# TECHNICAL BULLETIN

Date: Feb. 20, 2008  
Engineer: Larry Cuccio  
Page: 1 of 4

To: Distribution  
Product: TM9-1 Color Video Monitor  
Symptom: Vertical Deflection Problem

Fig.1

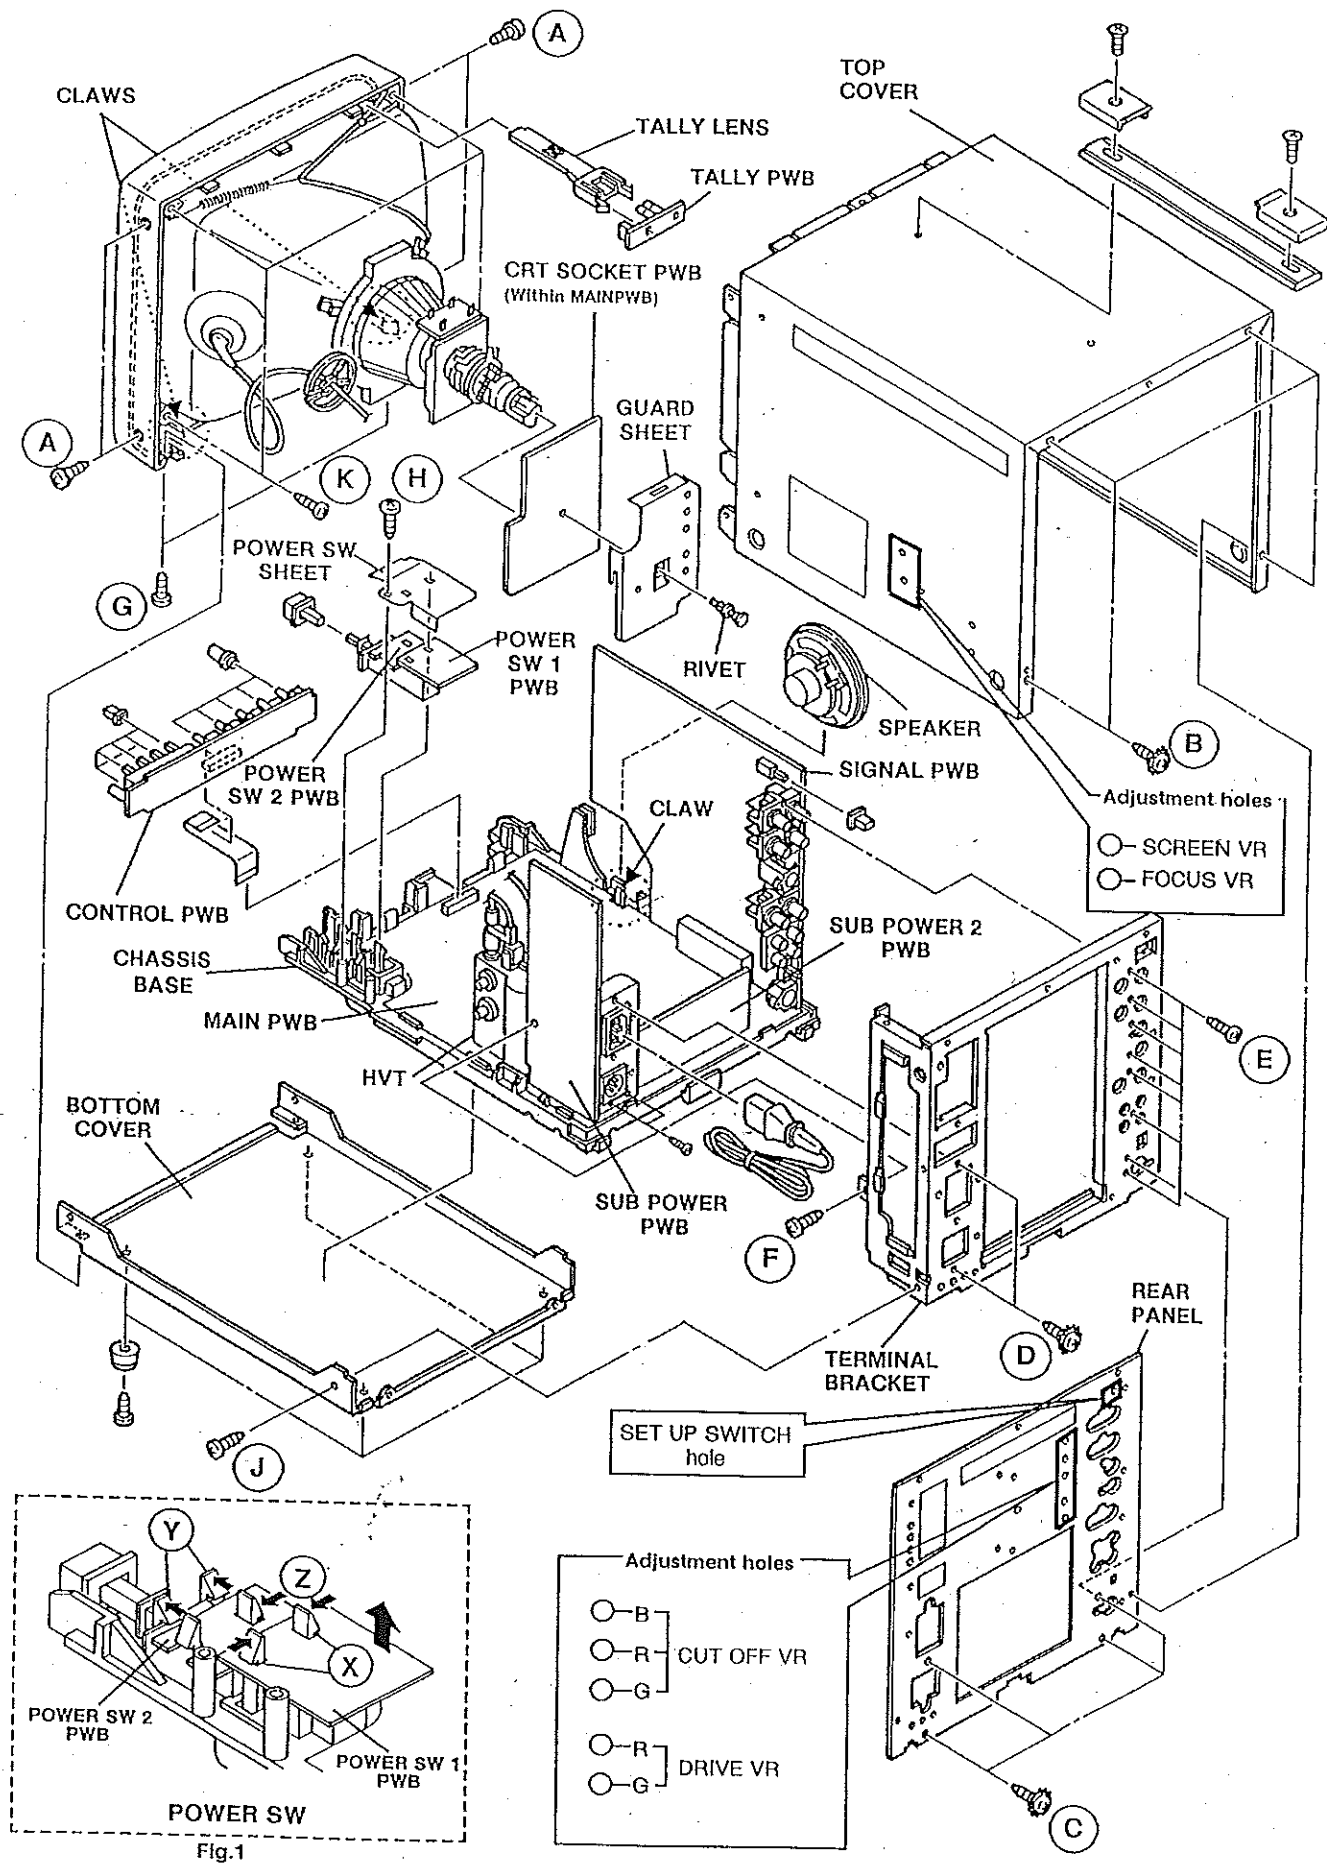
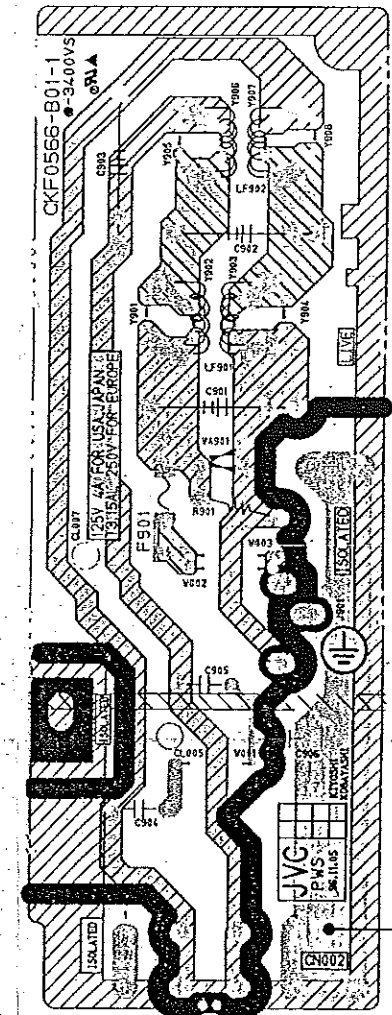
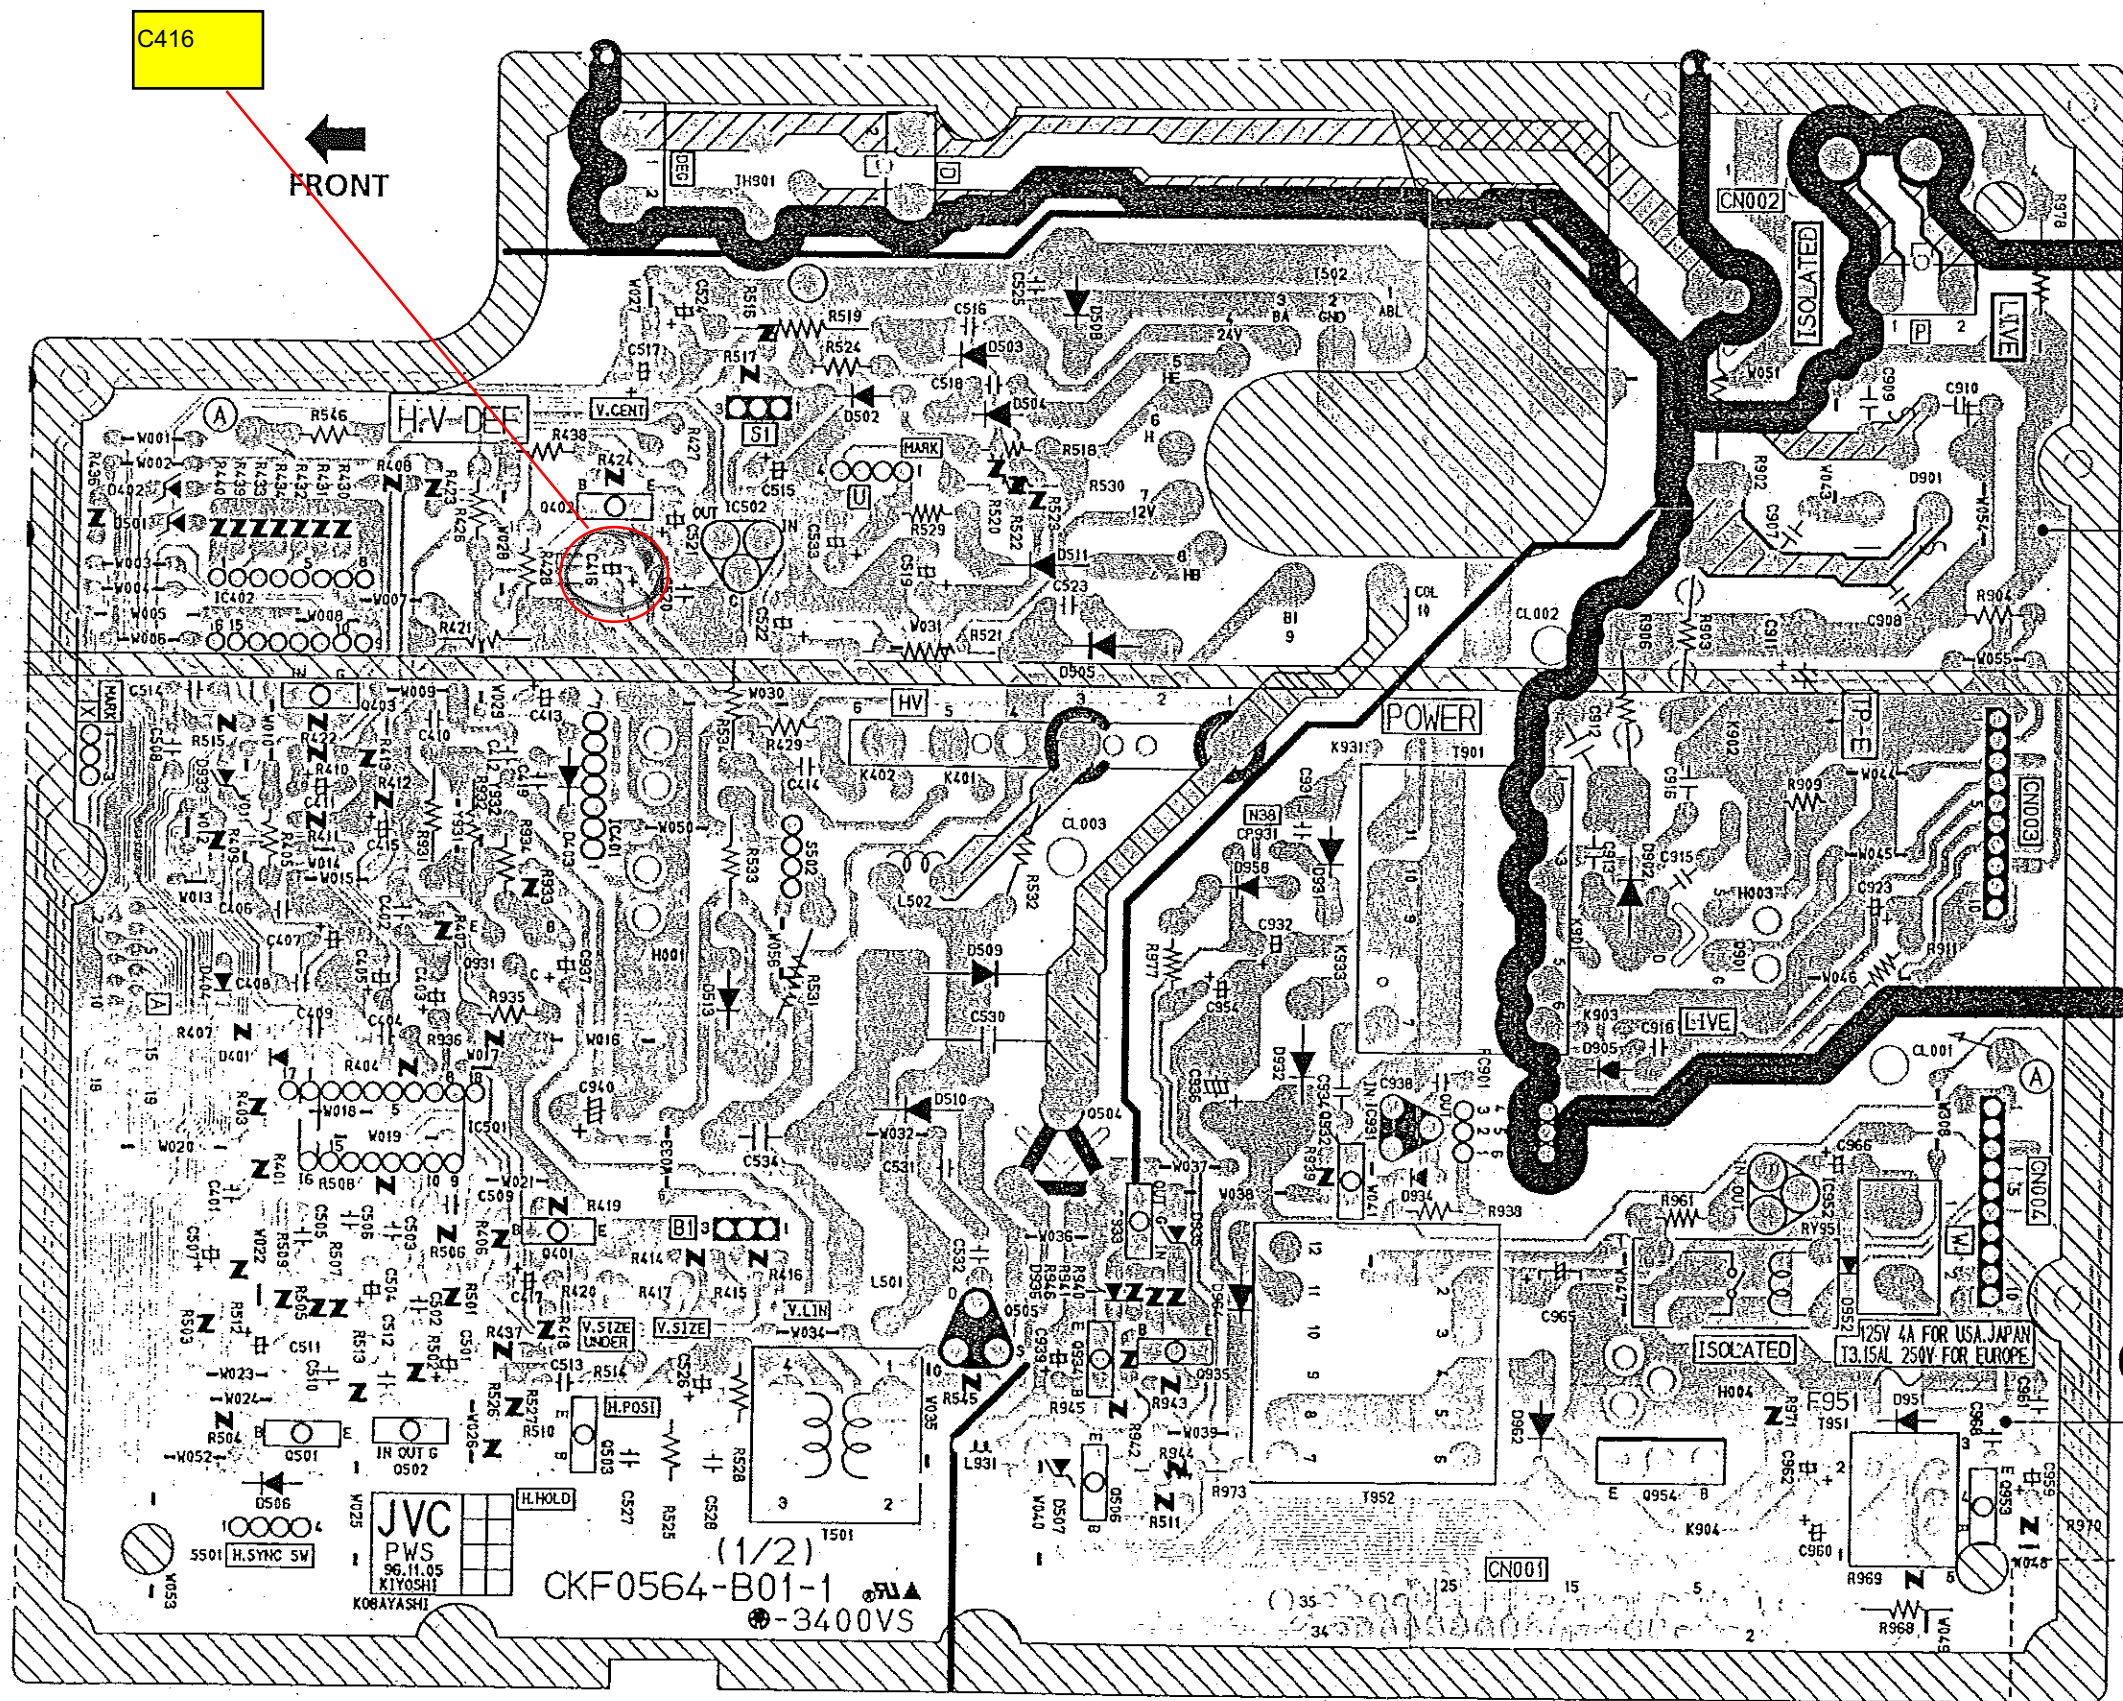
1. The exploded view diagram (Fig. 1) will show the location of the Main PWB, which must be removed for access to C416.
2. Remove C416. Refer to Fig. 2 for location.
3. Replace C416 with a new capacitor.

Capacitor, 470uf/25v, P/N QEHR1EM-477Z

Figure 2

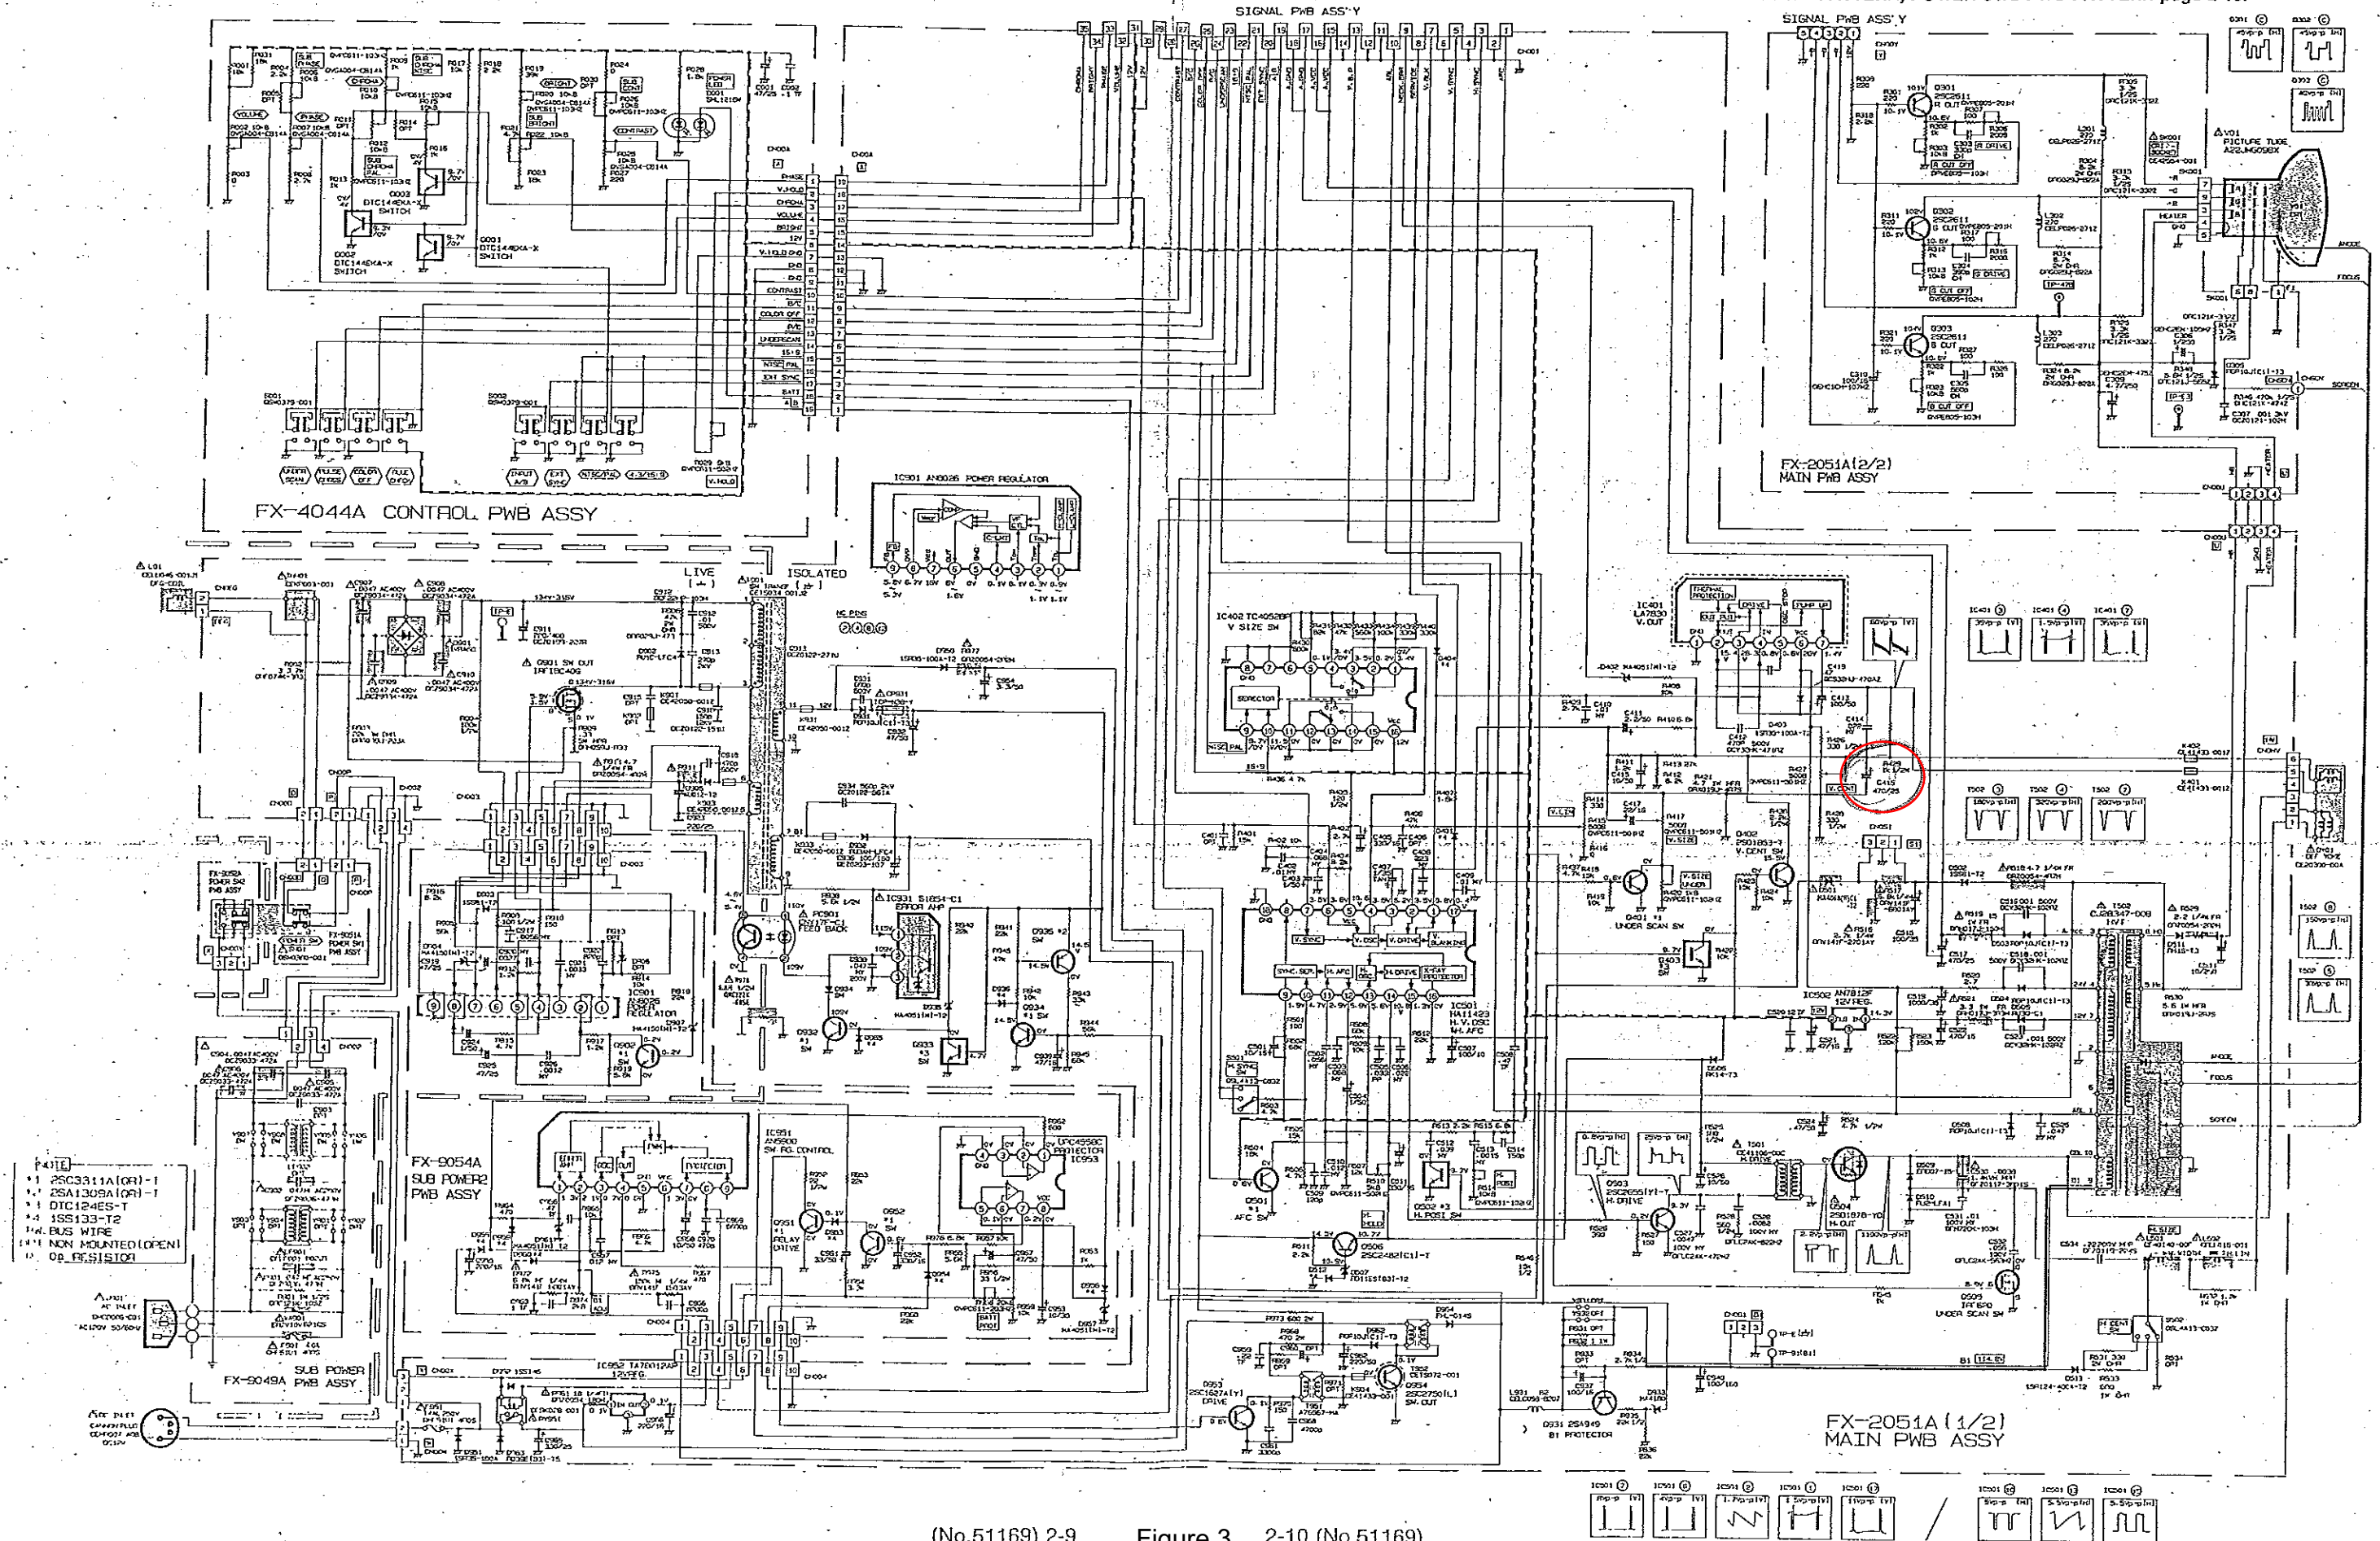
Capacitor C416 on the Main PWB may breakdown, causing a vertical deflection failure and loss of picture. The capacitor has reached the end of its life and must be replaced.
